Subject: Smoky Canyon Mine Remedial Investigation/Feasibility Study (RI/FS)  
Simplot's Responses to the October 14, 2020 Agency Comments for the  
Draft Feasibility Study Technical Memorandum #2:  
Detailed Analysis of Remedial Alternatives

**Simplot's Response to Comments (October 13, 2020)**  
**Smoky Canyon Mine Draft FS Technical Memorandum #2**

**Figure 1 – Estimated Selenum Concentrations at GW-25 (from Figure A-A7 of the draft report)**

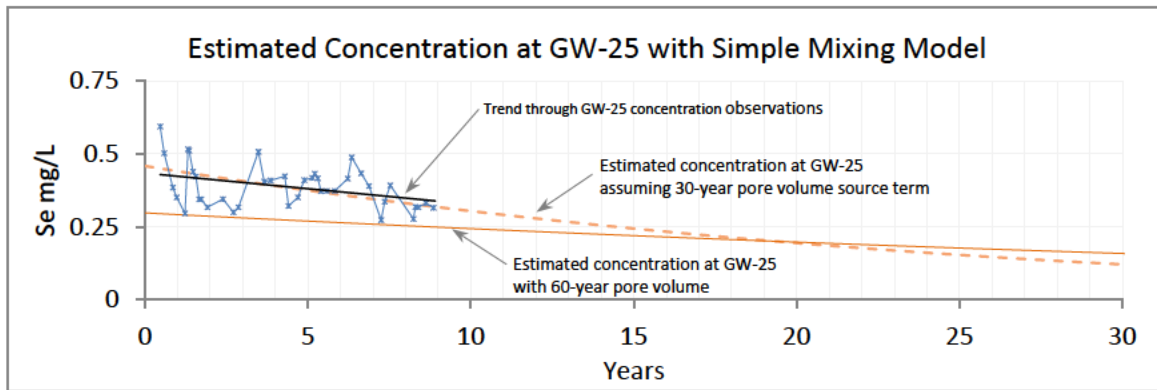
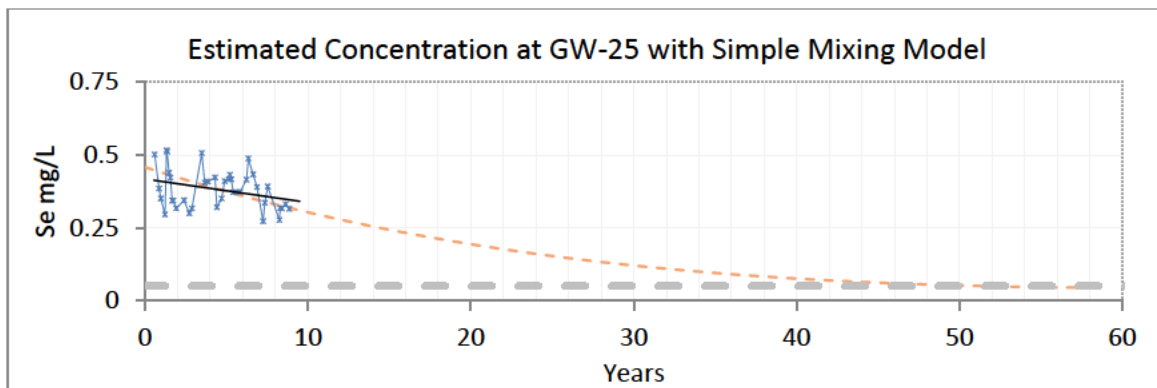
**GC-2** How do the alternatives meet the Remedial Action Objectives (RAOs)? RAOs are achieved by concentration reductions, but there is little to no discussion about this. The discussion in the text is focused on reductions in selenium loading.

**Response:** The model can be configured to provide concentration output. Our approach in the draft report was based on the concept that the relative performance of the remedial alternatives was the key metric in the evaluation. We were also concerned that producing concentration estimates would appear to indicate a level of certainty not representative of the assumptions made in the model. However, to address that comment, Simplot will be providing predictions of concentrations for selenium concentrations at groundwater wells and in surface water to evaluate each alternative's ability to meet RAOs. These modeled predictions will be provided in the revised report.

For example, the draft report provided a prediction of estimated selenium concentrations over time in Wells Formation groundwater at GW-25 (Figure 1):

Expanding the time axis on this graph (see Figure 2), provides a prediction that selenium concentrations at this well will reduce below the MCL in the 60-year timeframe. The revised report will provide a similar evaluation for Wells Formation groundwater at GW-16 and alluvial groundwater at GW-15, GW-22, and GW-26.
